HISTORIC AND DESIGN REVIEW COMMISSION

October 18, 2023

HDRC CASE NO:	2023-400
ADDRESS:	927 N OLIVE ST
LEGAL DESCRIPTION:	NCB 530 BLK 14 LOT E158. 33FT OF S 50FT OF A3 ARB A17 AT 927 N OLIVE
ZONING:	R-5, H
CITY COUNCIL DIST.:	2
DISTRICT:	Dignowity Hill Historic District
APPLICANT:	arturo lopez/A.L.E trucking
OWNER:	arturo lopez/A.L.E trucking
TYPE OF WORK:	Porch column modification
APPLICATION RECEIVED:	September 21, 2023
60-DAY REVIEW:	November 20, 2023
CASE MANAGER:	Claudia Espinosa

The applicant is requesting a Certificate of Appropriateness for approval to clad the existing wooden columns, capitals, and base with 1x8 softwood boards.

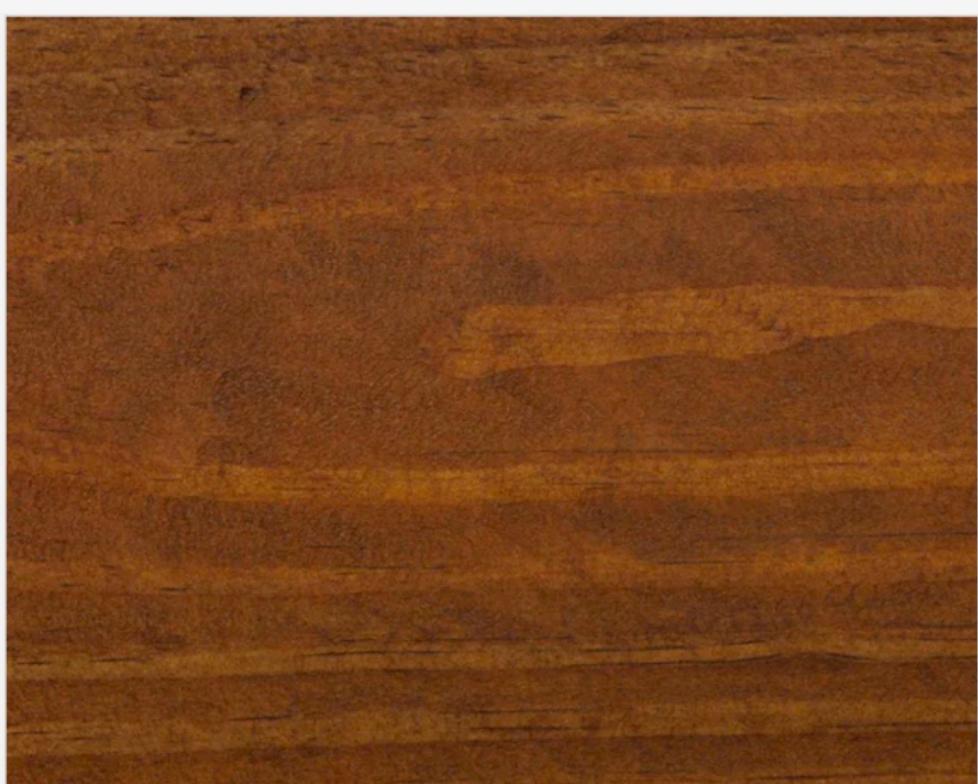
- b. PORCH MODIFICATIONS – The applicant has proposed to wrap the existing columns with 1x8 softwood boards (photos submitted indicate a very thin veneer being added.) According to the Historic Design Guidelines, porches should be reconstructed based on accurate evidence of the original, such as photographs. If no such evidence exists, the design should be based on the architectural style of the building and historic patterns. The proposed column modification is appropriate in terms of materials, but do not conform to the Guidelines which require a traditional column base and cap as well as chamfered corners.

Staff does not recommend approval of the porch column modifications based on finding b. Staff recommends that the applicant install a replacement column that meets the Guidelines with the following stipulations: The proposed wood columns should be no wider than 6" square, feature both capital and base trim and chamfered corners.
